SHOP DRAWING REVIEW

☐ REVIEWED AS REQUIRED BY THE CONSTRUCTION CONTRACT DOCUMENTS AND APPROVED, BUT ONLY FOR CONFORMANCE TO THE DESIGN CONCEPT OF THE WORK, AND SUBJECT TO FURTHER LIMITATIONS AND REQUIREMENTS CONTAINED IN THE CONSTRUCTION CONTRACT DOCUMENTS.
☐ REJECTED ☒ REVISE AND RESUBMIT ☐ FURNISH AS CORRECTED

Job Number: 57518.00
Reviewed By: E.A. FIALA
Date: 05/07/2014

VT Route 73 - Bridge 13 (Project # ER STP 0162 (19))
Rochester, VT
28'x10' Archcon w/ Wingwalls and Footings - Layout Views

2 S8.0 FOOTING TO WW ATTACHMENT DETAIL
¾" = 1'-0"

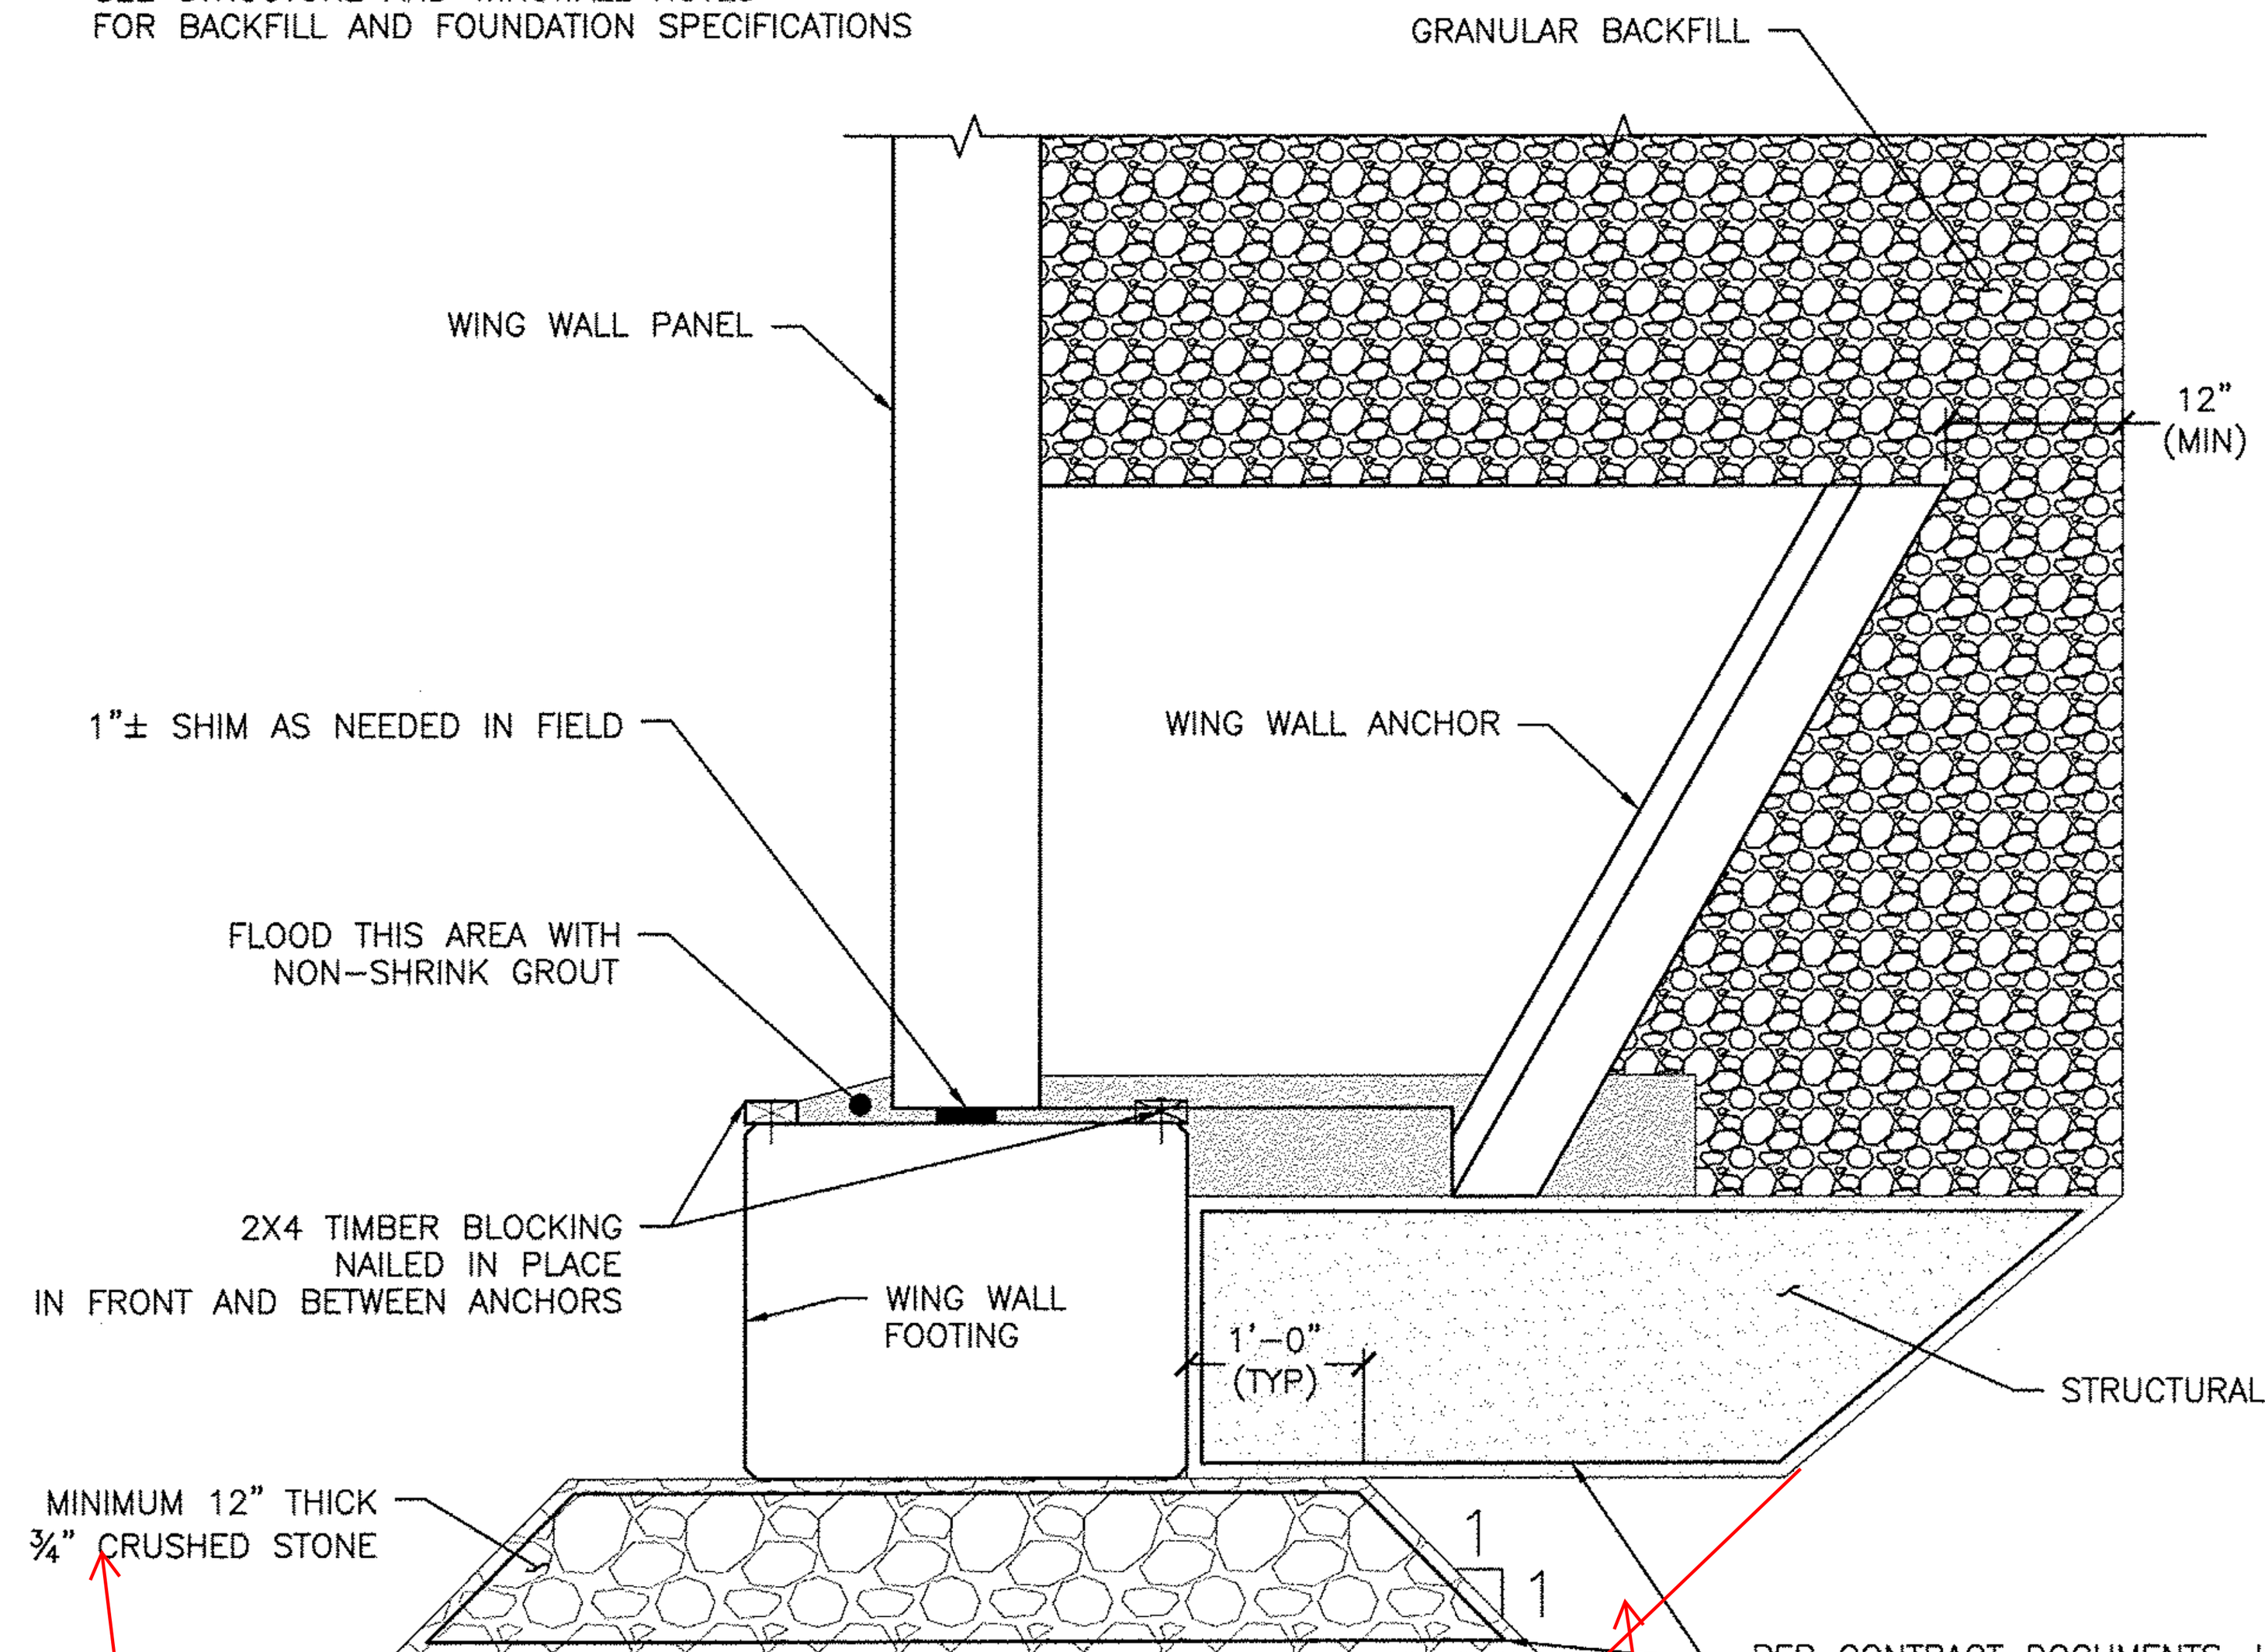
Subfooting? Will the subfooting be sloped 1:1?

What material will go here?
